2ND AND VIRGINIA

1931 2ND AVENUE EARLY DESIGN GUIDANCE #2 | JULY 23, 2019 | DPD #3033067-EG

KENGO KUMA // ANKROM MOISAN ARCHITECTS // BERGER PARTNERSHIP // PACIFIC VIRGINIA

Tower Form 1

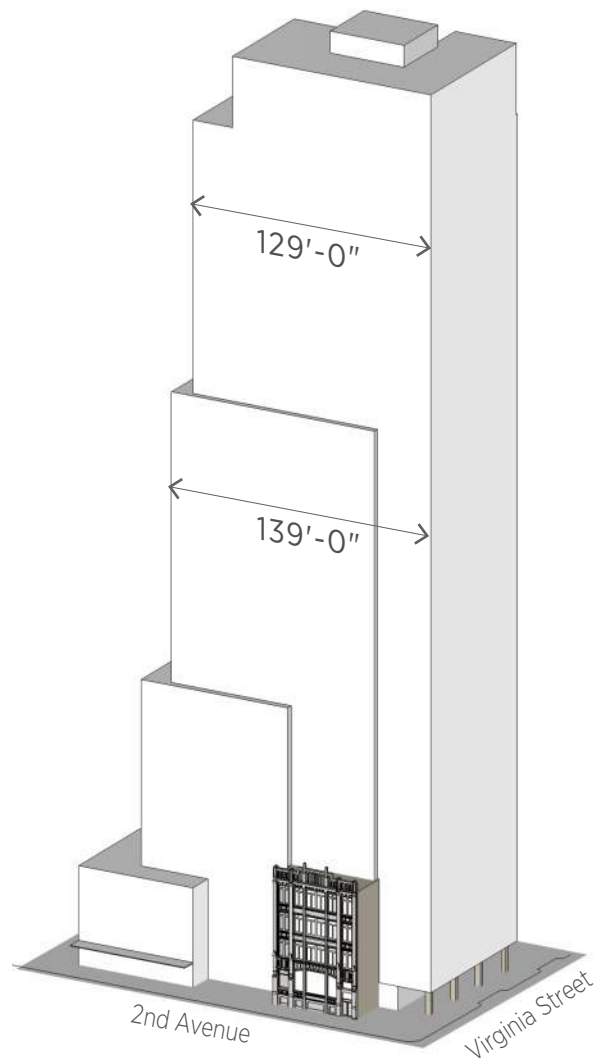
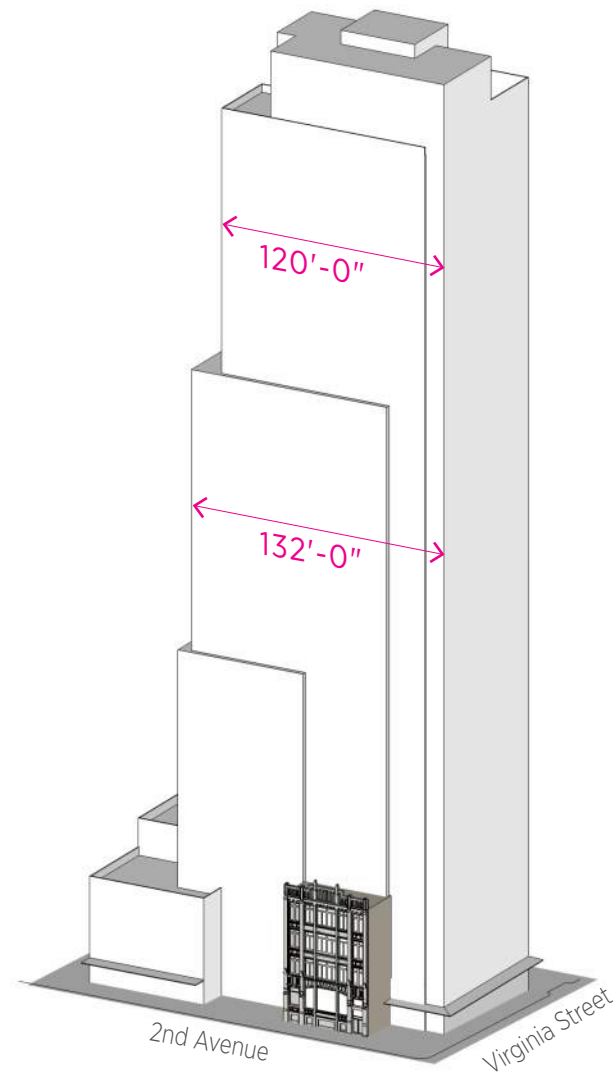
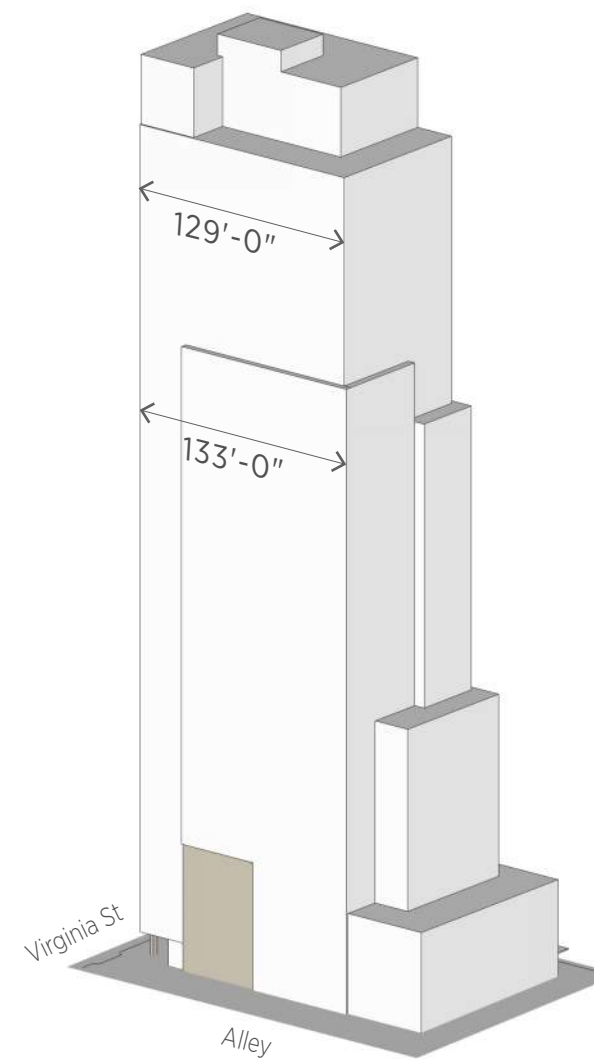
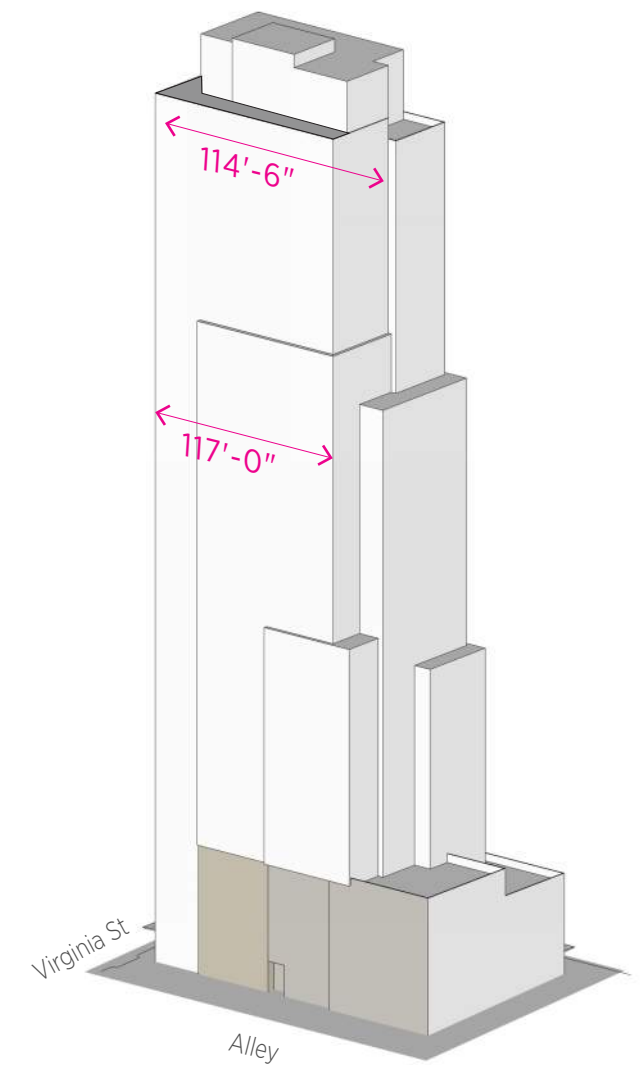
The Board was supportive of the concept of the stepping tower form as shown along 2nd Avenue. However, the Board commented it was not clear how the stepping would be carried around to all facades of the tower. At the next meeting the Board would like to review the following:

- i. Diagram of how the design concept is carried to all facades.
- ii. Clarification on how the tower form meets the podium and landmark structure.
- iii. Additional images of each facade, including images from both the City and pedestrian view.

The Terminal Sales Annex sets up the alignments for the telescoping massing, and provides inviting and usable open plazas to highlight the landmark at the ground level.

In addition to reducing the tower width, the design team has increased the stepping on three sides of the building keeping the north facade as an unmodulated grounding element. Each tier of the telescoping forms wrap around from east facade to west facade, while the final and the tallest tier anchors the north facade, culminating in the tower terminus.

- The overall tower width has been reduced.
- The average floor plate is well below the maximum average floor plate allowed.

Tower Terminus 2

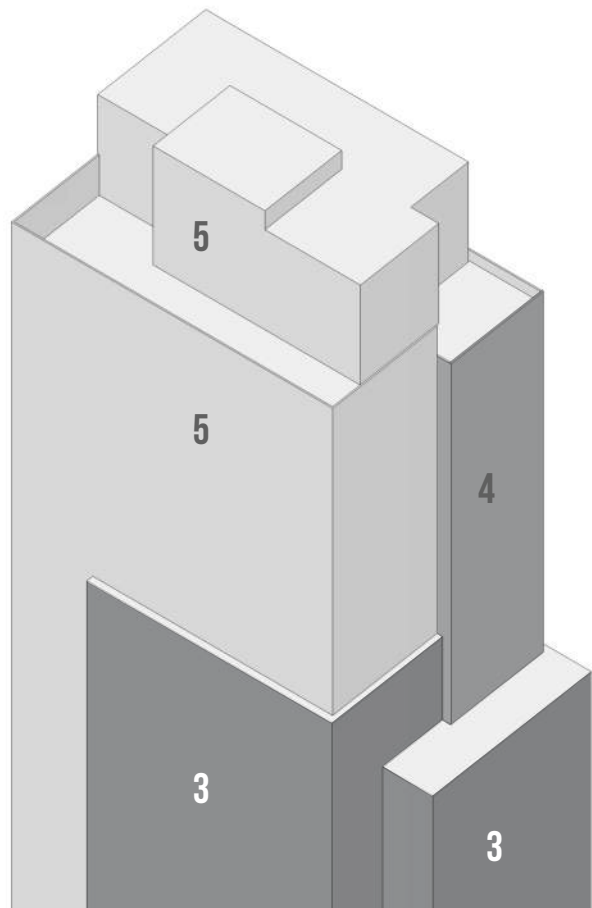
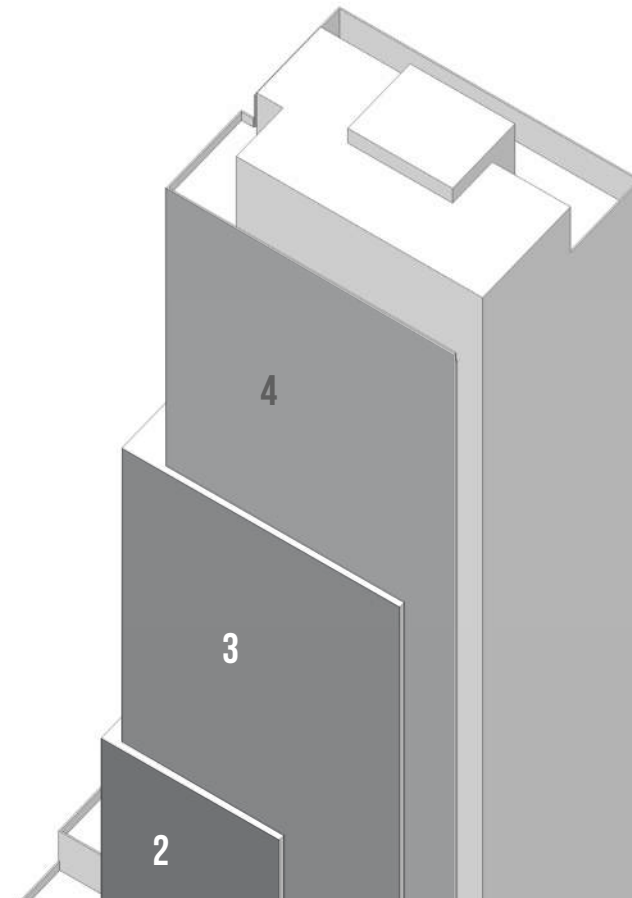
The board was supportive of the direction of the tower terminus, however noted, it was unclear how the stepping concept resolved itself at the tower’s top as the setbacks were inconsistent around the tower terminus form which seemed to conflict with the overall tower concept and cohesion. At the next meeting the Board requested:

i. Refinement of the tower terminus, which supports a logical transition and termination of the tower’s stepping concept. The Board further noted while the street-level would be marked by the landmark, the tower form and terminus should add to the City’s skyline and be designed as such.

The tower top is part of the final and tallest of the telescope massing. The telescoping forms align with Terminal Sales Annex building, reference notable works like Seattle Tower, and culminate at the terminus; extending the architectural logic from the foundation, through the body of the building, up to the last step. The tower facade is designed to be more reflective towards the roof, blending into the sky.

BAD EXAMPLES

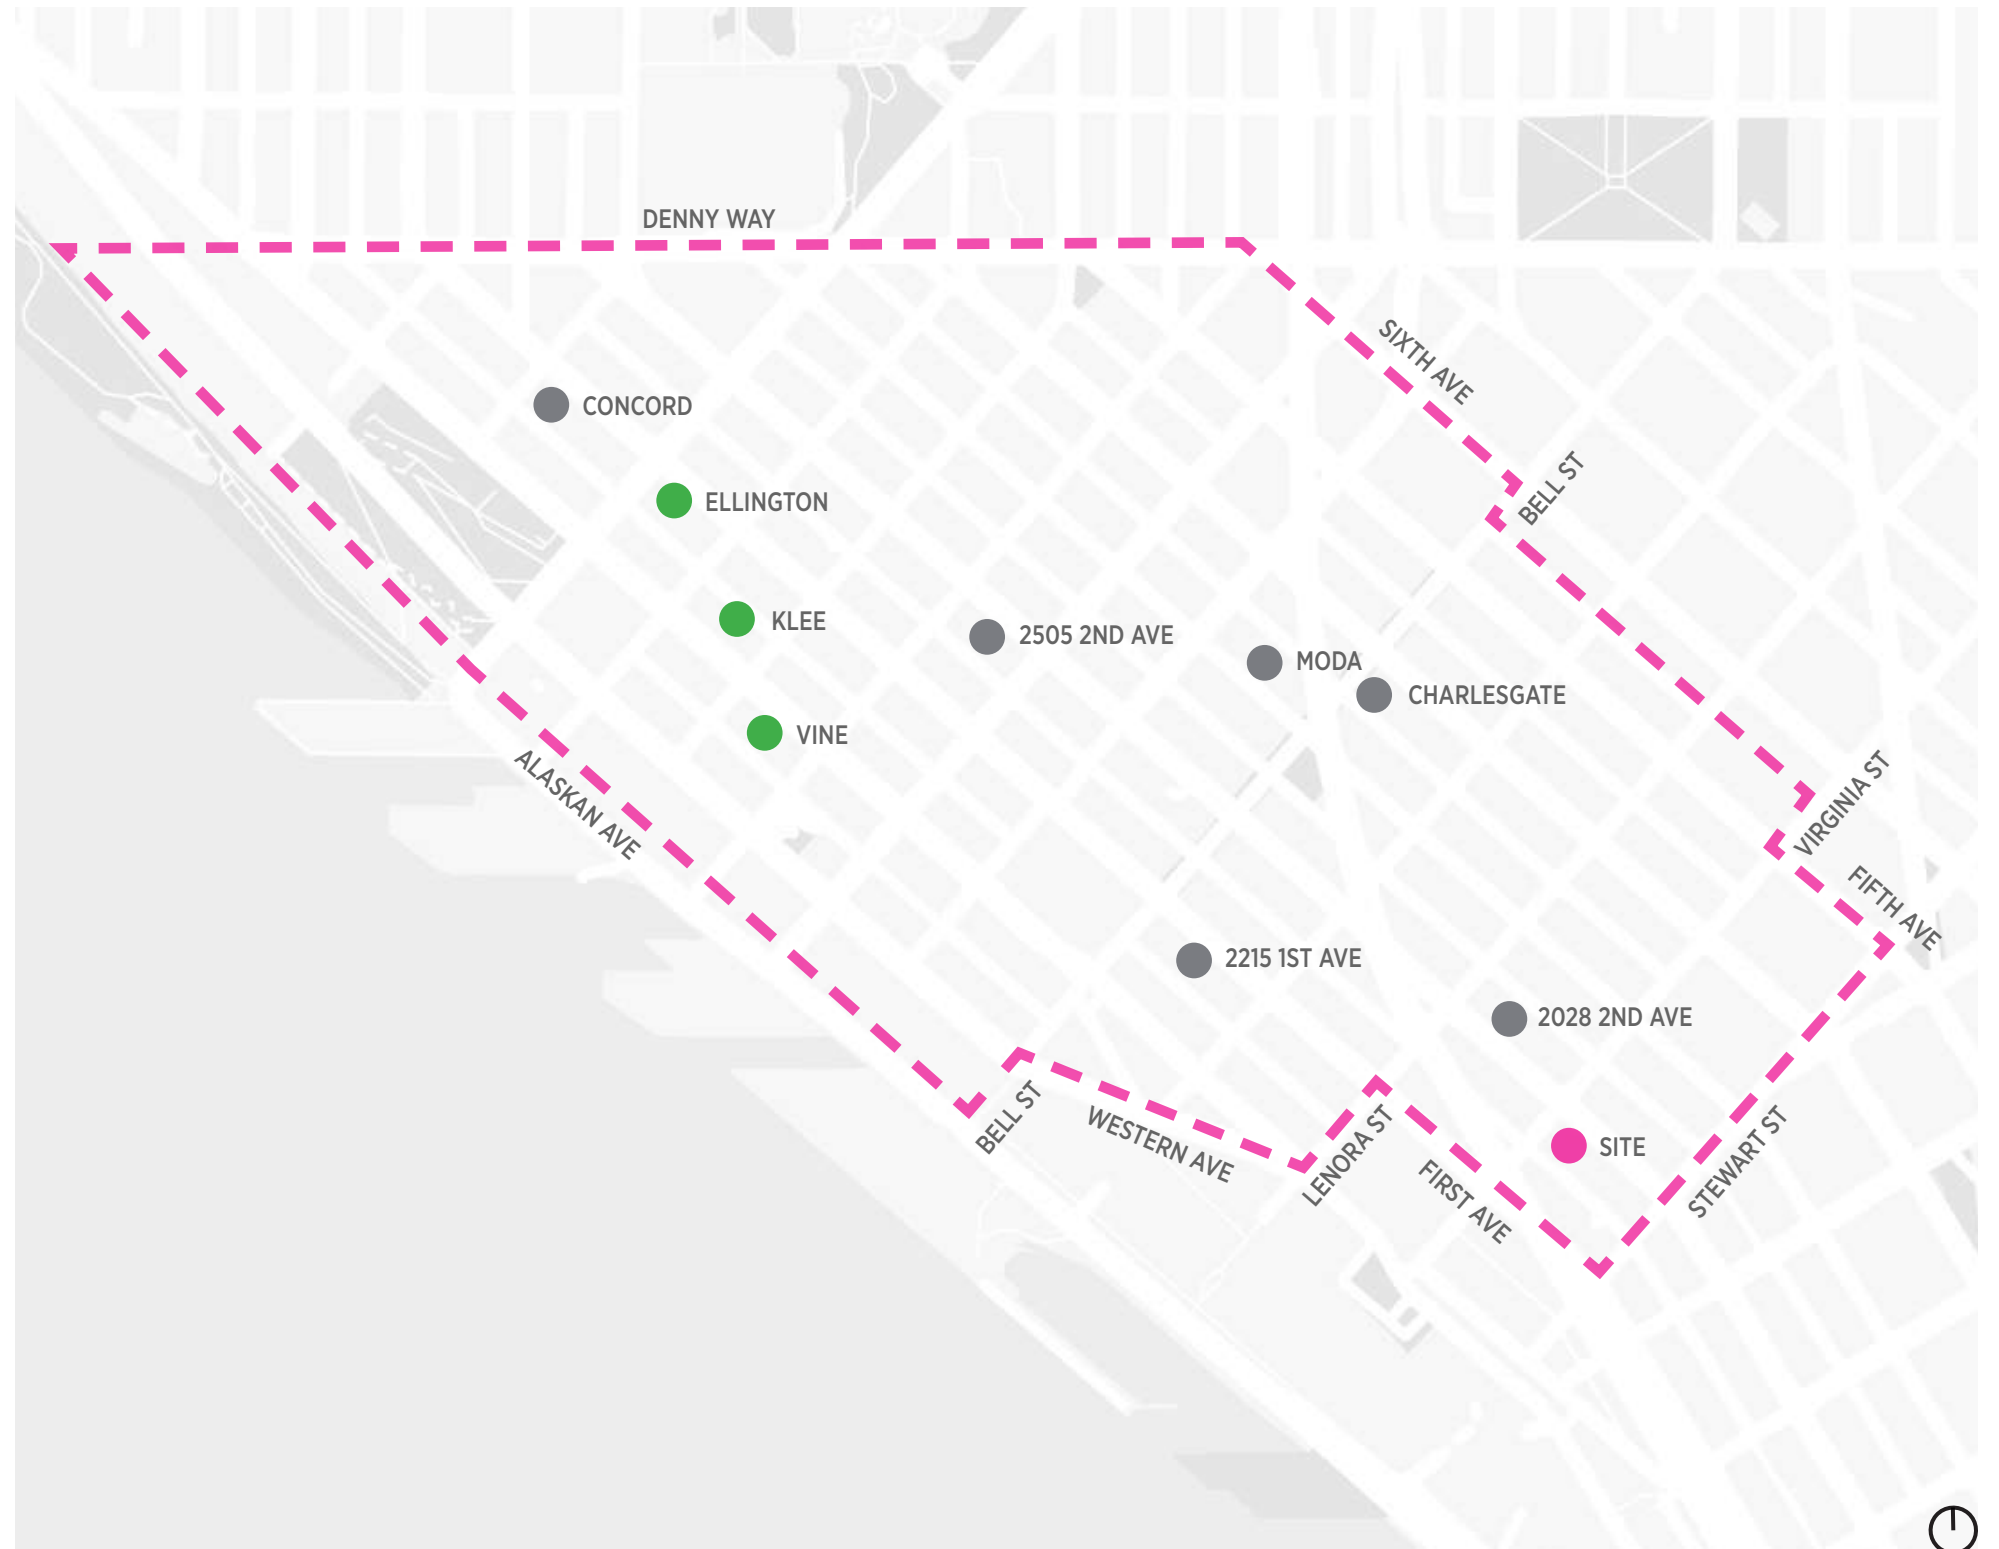
Overall the Board was pleased with the elevation at street-level along 2nd Avenue including the small open areas to the north and south of the landmark. However, the Board echoed public comment regarding the desire for an active street-level and expressed concern related to activation of the setback area becoming inactive, dead space. At the next meeting the Board would like more information related to these setback areas including:

- i. Study of good/bad examples of projects within Belltown that utilize larger setbacks/ entry courts.
- ii. Illustration of how programming and design of the adjacent uses and spaces will support activated areas. The Board specifically noted that lobby uses are of concern and should be designed thoughtfully with activation in mind.
- iii. Sections clarifying relationship to grade (along the entire street frontage).

The project team has explored Belltown looking for good and bad examples of courtyards and mid-block plazas. The more successful examples all had human-scaled features such as planters, seating elements, artistic installations, etc. while encouraging flexibility in use.

The project proposes an interactive entertainment space in front of the mid-block plaza with opportunities of interior program spill outs. The landscape is designed specifically to encourage flexible use. The party wall treatment of the Terminal Sales Annex building will provide a special backdrop to both plazas, enriching pedestrian experience.

EDG 1

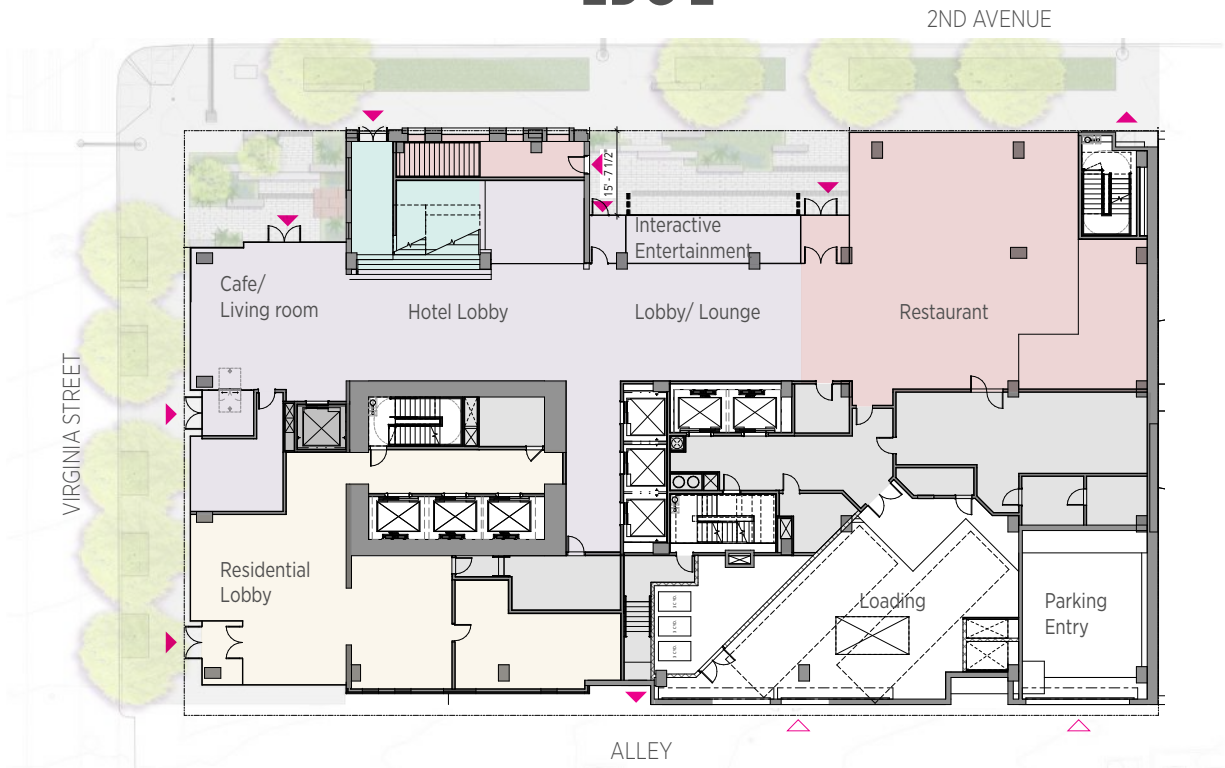
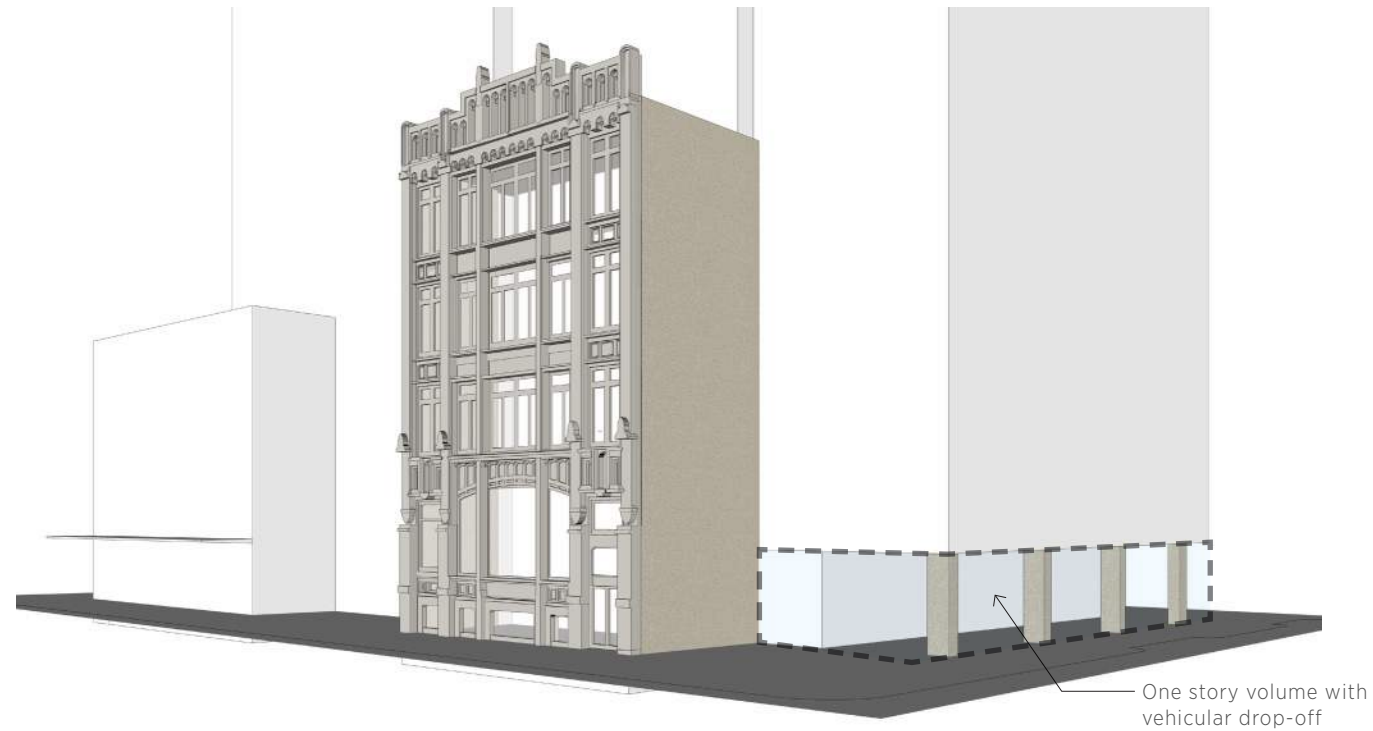
The Board echoed some public comment as they were not supportive of locating vehicular access off of Virginia Street as this interrupted the pedestrian experience both in terms of activation and safety of downtown streets by increasing curb cuts. The Board further noted that they have seen recent projects integrate porte cocheres successfully at the alley and questioned why this was not feasible. Though the Board acknowledged the challenges of programming uses around the core structure, they did not believe the presented design served as an asset to the pedestrian realm and commented the design was seemed to create a car focused area. At the next meeting the Board would like to see the following:

- i. Studies of alternative vehicular access location
- ii. Activated street response
- iii. Minimize curb cuts
- iv. Update on review of traffic information by SDOT/ SDCI transportation planner.

Per the recommendation of the Design Review Board, the project team has removed the vehicular drop-off area along Virginia Street. Instead, the street-level facade is occupied by active uses such as Cafe/Living room at the NE corner, hotel main entry, as well as residential entry and lobby/ lounge. This will create more active and safe pedestrian environment along Virginia Street.

In order to mitigate concerns regarding congested alley, the project sets back two additional feet for about 2/3 of the alley facade beyond the required 2ft alley dedication, creating safer and more usable alley.
